Subject: MHI's Responses to US-APWR DCD RAI No.38

Responses to Request for Additional Information No.38 Revision 1

US-APWR Design Certification

RAI NO.: NO.38 REVISION 1
SRP SECTION: 15.00.03 – Design Basis Accidents Radiological
Consequence Analyses for Advanced Light Water
Reactors
APPLICATION SECTION: 15
DATE OF RAI ISSUE: 7/24/2008

Figure 15.00.03-17-1 Site Plan with Release and Intake Locations

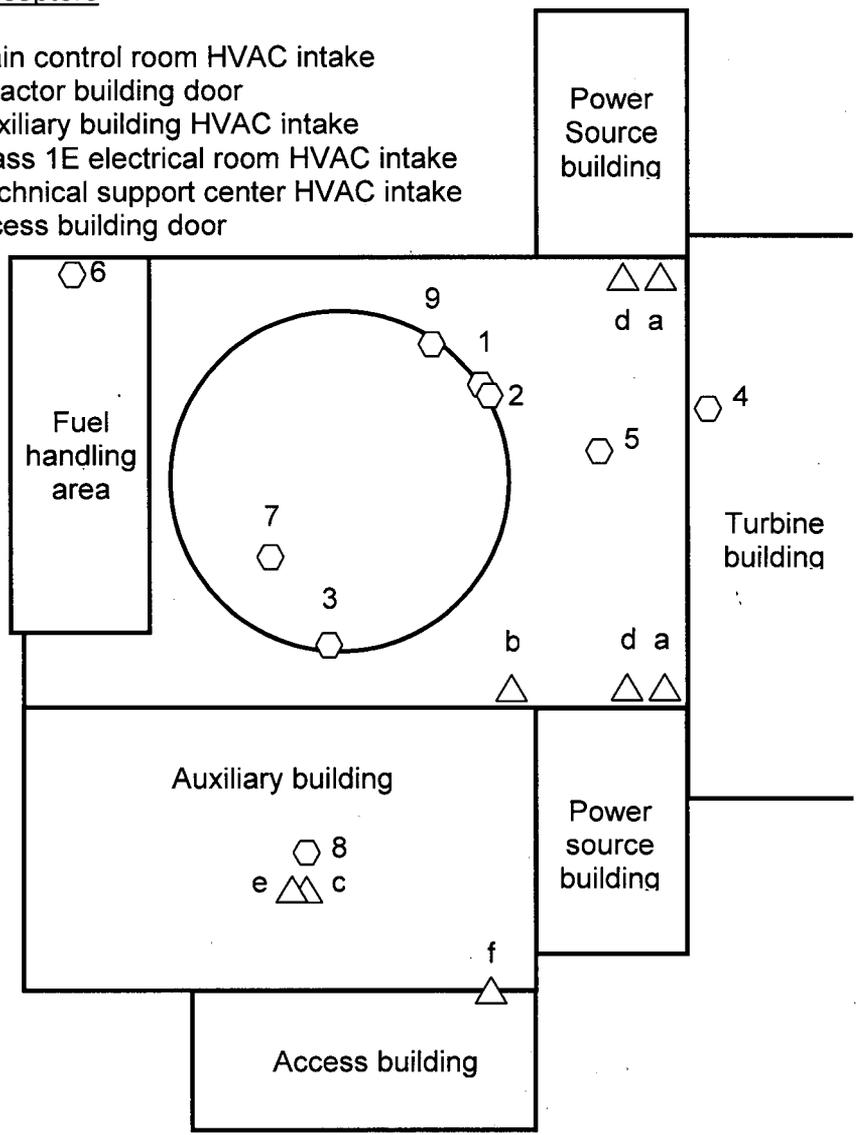
DCD 15.6.5.5.1.3 states that the technical support center (TSC) dose consequences are represented by the control room dose consequences and there are some qualitative statements about the relationship of the TSC model to the control room model. Please provide the details of the TSC dose consequence model, sufficient for the NRC staff to determine independently if the control room dose consequence model is bounding for the TSC. Include information on the TSC intake and unfiltered inleakage receptor locations sufficient for the NRC staff to determine independently that the TSC atmospheric dispersion factors are bounded by the control room atmospheric dispersion factors for all DBAs.

The TSC atmospheric dispersion factors (χ/Q values) are compared to the MCR values for all DBAs in Tables 15.00.03-17-2 through 15.00.03-17-7. Since the access building in which TSC is located does not have any exterior doors, the TSC inleak for all the DBAs, except for the failure of small lines carrying primary coolant outside of the containment, is assumed to be equal to the TSC intake, which is located on the roof of the auxiliary building.

The χ/Q values shown for the RCS sample line are used for the failure of small lines carrying primary coolant outside containment shown in Table 15.00.03-17-5. Based on the layout provided in Figure 15.00.03-17-1, the reactor coolant is assumed to spill in the auxiliary building, be discharged to the atmosphere from the plant vent, and be transferred to the TSC via the TSC HVAC system. However, the TSC dose consequence evaluation uses χ/Q values based on the conservative assumption that radioactive materials leaked in the auxiliary building are transferred directly to the TSC through the access building door. Therefore, the failure of small lines carrying primary coolant outside containment dose consequence assessment uses χ/Q values for TSC intake and inleak at the access building door.

Figure 15.00.03-18-1 Modeling method for evaluation of direct dose from reactor containment at the time of the accident

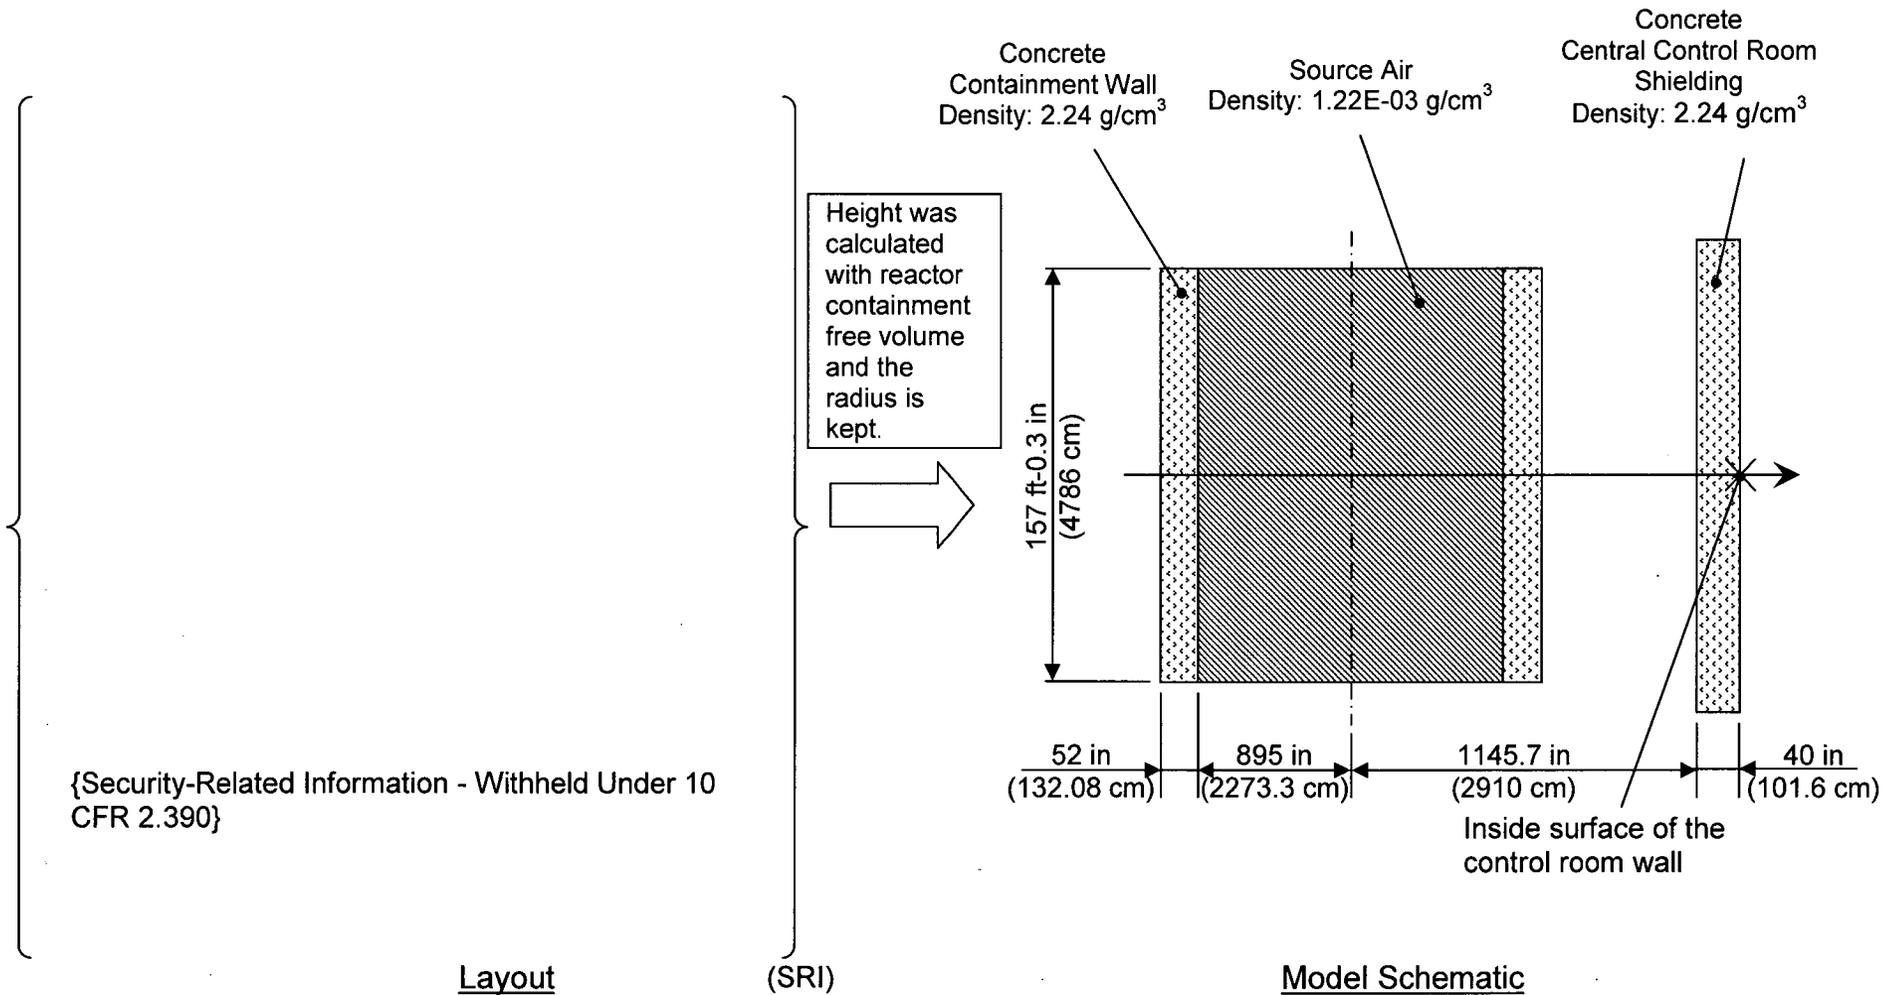
Provide the control room direct dose calculations and justify the assumptions and inputs. Indicate the receptor location for the operator used in the control room direct dose model.

Figure 15.00.03-18-1 provides a schematic description of the containment source model. The source term is modeled as a cylinder whose radius and height are determined from the radius and free volume of the reactor containment. The operator's position is on the inside surface of the control room wall.
